CITY OF FORT BRAGG

DATE: April 3, 2024
TO: CDD / GOC Construction
FROM: Kevin McDannold; Engineering Technician, Public Works
SUBJECT: PW Comments for CDP 1-24; 620 S Franklin

RE: CDP 1-24, U 1-24

STANDARD SIDEWALK

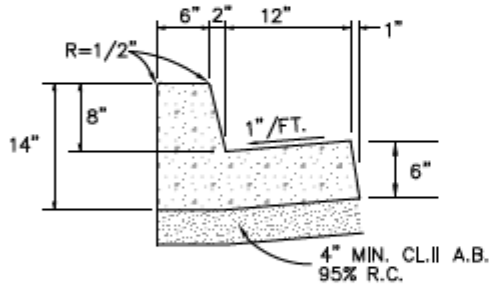
- d. Sewer Cleanout is required.
4. **Circulation, Access, & Frontage:**
 - a. Although sidewalk is present on S. Franklin Street frontage, existing driveway cut shall be abandoned and replaced with standard sidewalk per City Standard 205.
